Sea Link

**Volume 9: Examination Submissions**

Document 9.121: Applicant's Comments on Other Submissions Received at Deadline 4

Planning Inspectorate Reference: EN020026

**Figure 2.** Recordings of most common cetacean species within the dataset. Data collected from the following sources: Marine Data Exchange, National Biodiversity Network Atlas, Sea Watch Foundation, Joint Cetacean Data Programme, Kent & Essex IFCA, National History Museum strandings.

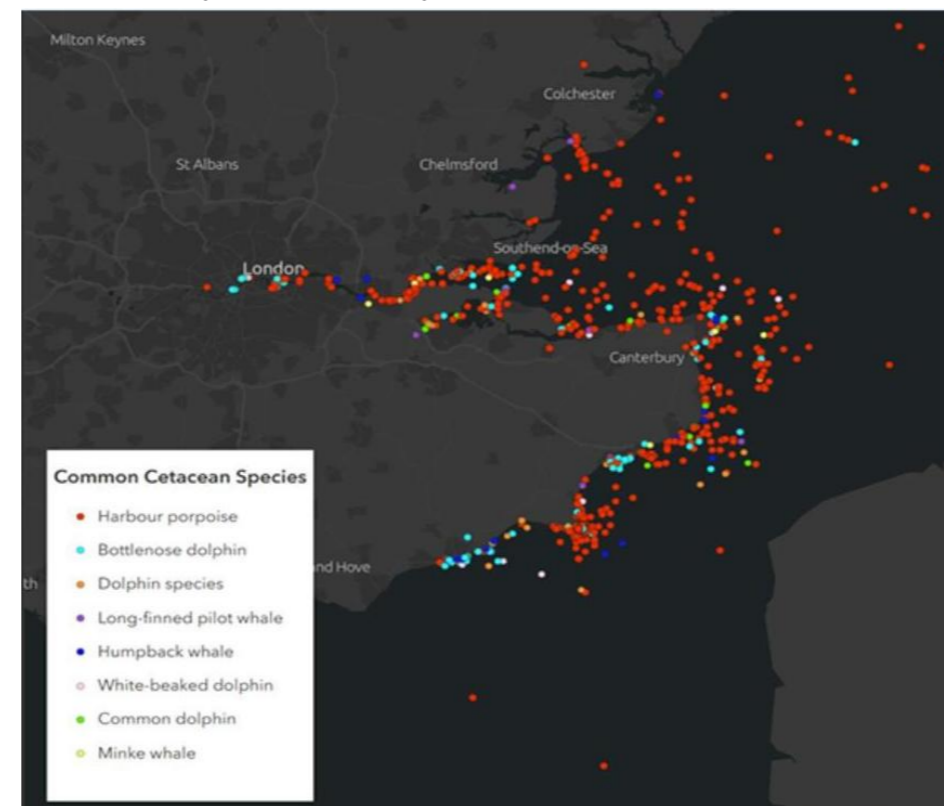
The below figures are sourced from the KDP report, with Sea Watch Foundation having kindly provided permission for their use in this Examination. They illustrate the growing body of evidence that cetaceans regularly occur in waters around Thanet and the wider Kent coastline. Figure 2 – Common Cetacean Species, shows the collated species records from MDE, NBN Atlas, Sea Watch Foundation, JCDP, KEIFCA and the Natural History Museum, and Figure 6 shows the composite heatmap of cetacean sightings, which together highlight consistent use of the wider area rather than sporadic or exceptional occurrences.

For example, Figure 2 from the KDP report plots cetacean sightings but in the absence of any description of the time period, or level of sightings effort, over which the KDP data were collected, it is not possible to understand their relevance other than some individuals of these species have been observed in the waters around Kent, which has already been presented in the baseline characterisation. Thus, the information presented in Figure 2 is consistent with the baseline already presented but does not provide data that would be suitable for a quantitative assessment.

#### Plot 2/20 - point B

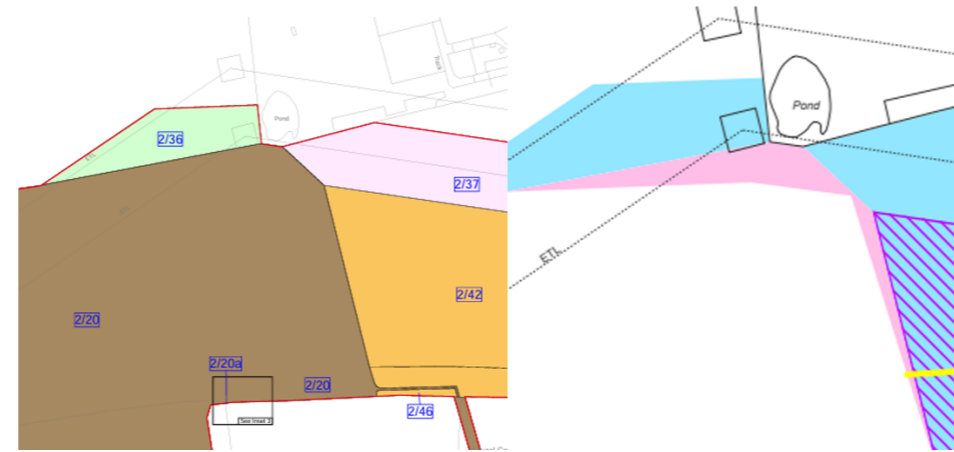
National Grid have not provided any rationale for the purchase of the land shown coloured pink on the plan extract below, forming part of Land Parcel 2/20. Scottish Power Renewables have already acquired the land to the 'south' of that shown coloured pink to facilitate their development of a permanent access to serve the Transformer and Sub-Station sites. National Grid have failed to provide any justification for their need to acquire this land and we do not believe that its' inclusion is necessary for the delivery of the Project, as Scottish Power Renewables have already been granted planning permission for the development of an access to the site.

The Applicant confirms the pink area on the below Heads of Terms plan, part plot 2/20, referred to by Mr Rix is under Option to SPR as shown in the plan provided by SPR and has not been excluded from the SPR Option agreement.

The **Project Description in Part 1, Chapter 4 [REP1A-003]** sets out the rationale for inclusion of the SPR order limits within the Sea Link Order Limits, which is why this has been included in the Sea Link Order and related Heads of Terms.

#### Plot 2/20 - point C

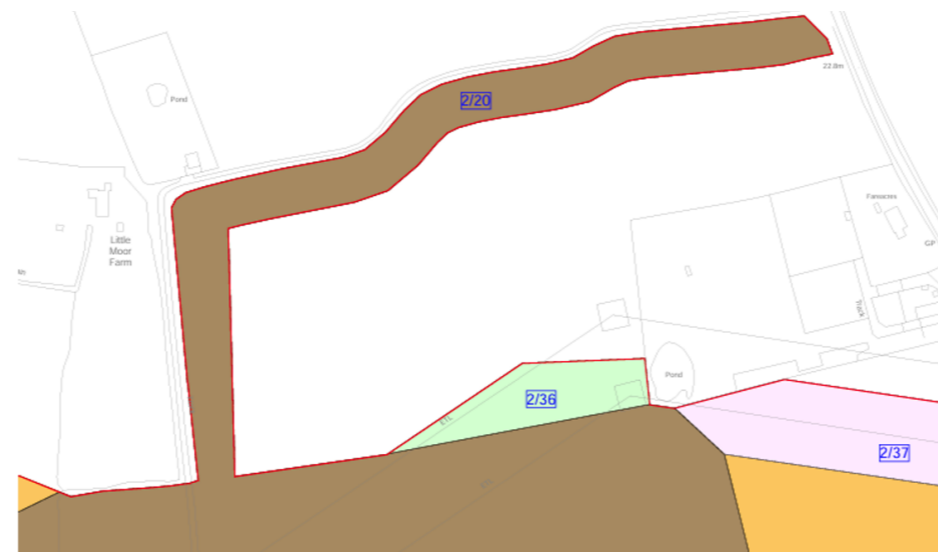
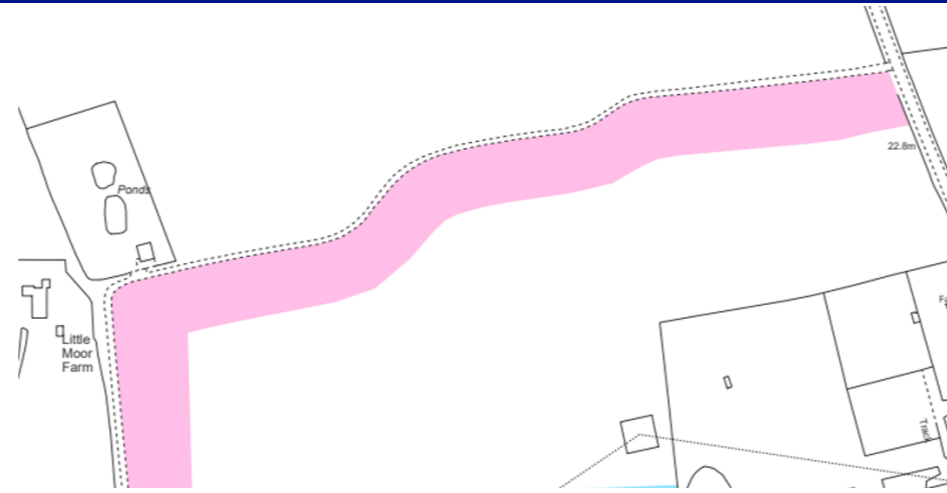
National Grid have not provided any rationale for the purchase of the land shown coloured pink on the plan extract below, forming part of Land Parcel 2.20 which 'replicates' the landscape mitigation already proposed to be implemented by Scottish Power Renewables, which is not proposed to be planted predominantly to the north side of the track, to account for the existing buried services serving the property known as 'Little Moor'. National Grid have failed to provide any justification for their need to acquire this land and we do not believe that its' inclusion is necessary for the delivery of the Project.

The Applicant confirms the pink area on the below Heads of Terms plan, part plot 2/20, referred to by Mr Rix is under Option to SPR as shown in the plan above provided by SPR and does not appear to have been excluded from the SPR Option agreement.

The **Project Description in Part 1, Chapter 4 [REP1A-003]** sets out the rationale for inclusion of the SPR order limits within the Sea Link Order Limits, which is why this has been included in the Sea Link Order and related Heads of Terms.

#### Plots 2/38, 2/39 and 2/99

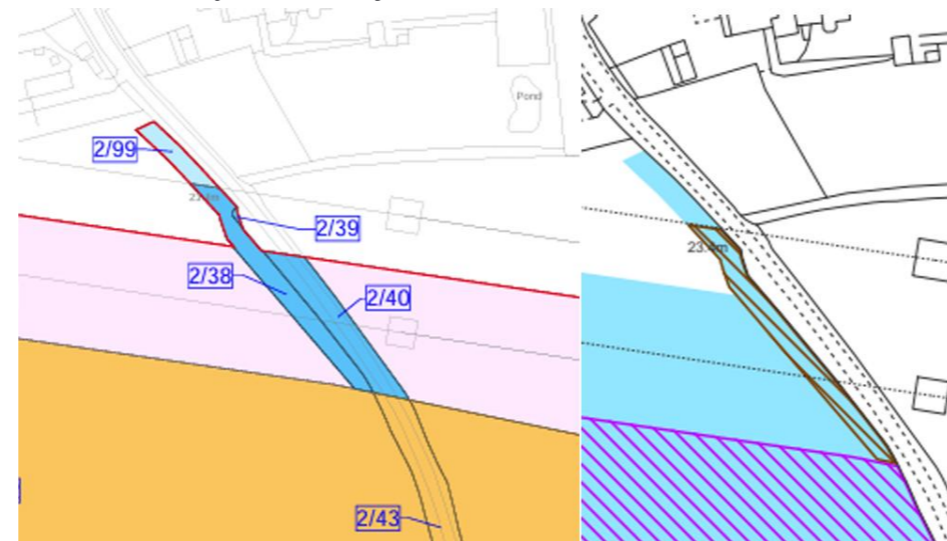
It is unclear 'why' there is a need for the compulsory acquisition of the rights shown on drawings below. We understand that there may be a proposal to plant hedging along the roadside boundary but this has not been discussed to date and such planting will simply sterilise the field boundary. There is an existing hedge on the roadside boundary, planting a further hedge on the field side, will create maintenance issues for both the hedge and ditch and achieve little by way of additional landscaping. National Grid have failed to provide any justification for their need to acquire rights over this land and we do not believe that its' inclusion is necessary for the delivery of the Project.

Plots 2/38, 2/39 and 2/99 again are under Option to SPR for acquisition.

#### Plot 2/11

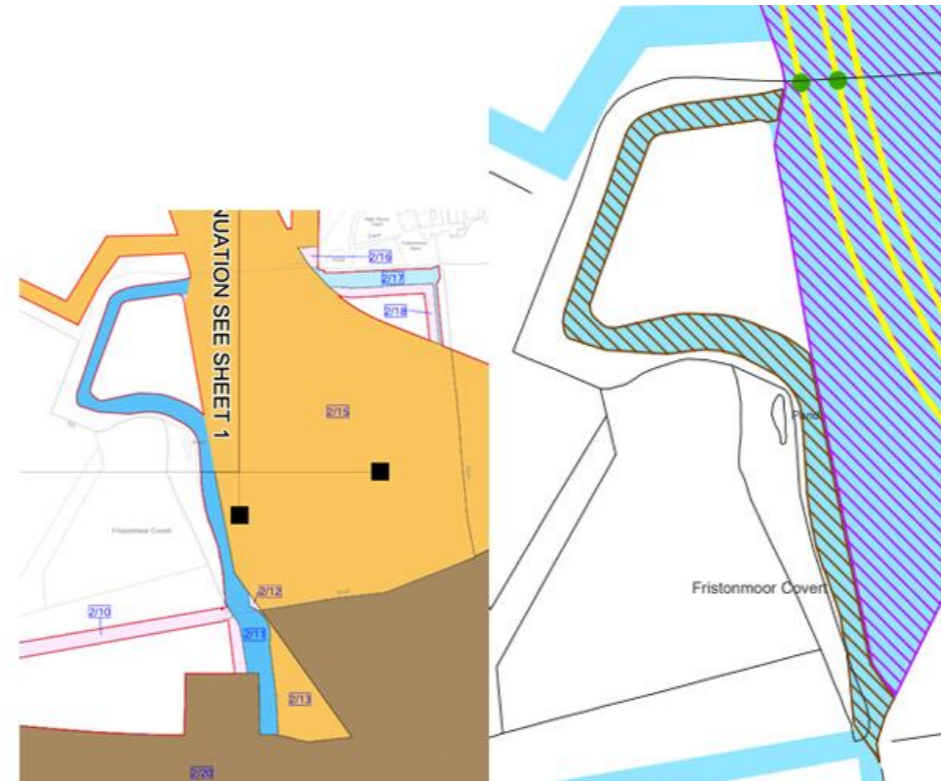
National Grid propose to acquire permanent rights of access over the land shown hatched brown below to facilitate access to their proposed junction boxes, marked in green. At previous meeting, in early 2025, with National Grid representatives it was suggested to them that an alternative access, over the existing drive leading Fristonmoor Barn and High House Farm, would have provided them with access to within a much shorter distance of the same location. We do not understand why this alternative option was not explored, rather than impact a productive arable field. In the event

that this alternative was deemed 'unacceptable', then given the location of the permanent PROW (a footpath) being installed by National Grid which effectively already divides the field, could the required rights of access not run in parallel with the PROW to minimise the long term sterilisation of the land? Surveys have already been completed over both alternative routes and adoption of such, would not delay delivery of the Project. National Grid have failed to provide any justification for their need to acquire rights over this land and we do not believe that its' inclusion is necessary for the delivery of the Project, given the less disruptive alternative options available.

Plot 2/11 is owned by Mr Rix and not subject to SPR Option. It is included in the Application as Class 5 compulsory rights of access. This is to enable the Applicant to access the cables and junction boxes post construction. It is necessary for the applicant to be able to access the junction boxes for inspection and maintenance. The Applicant will liaise with Mr Rix to establish if there is a suitable alternative but until an alternative is agreed and documented it must retain this route.

**Land Parcels 2/17 and 2/18**

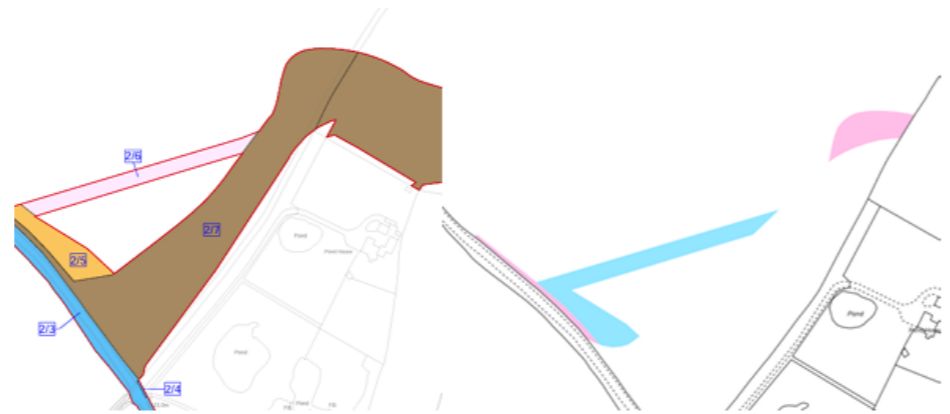
National Grid have not provided any rational for the purchase of the land shown coloured pink on the plan extract below, forming part of Land Parcel 2/17 which 'replicates' the landscape mitigation already proposed to be implemented by Scottish Power Renewables for this purpose. National Grid have failed to provide any justification for their need to acquire rights over this land and we do not believe that its' inclusion is necessary for the delivery of the Project.

Plot 2/17 and Plot 2/18 are under Option to SPR for acquisition.
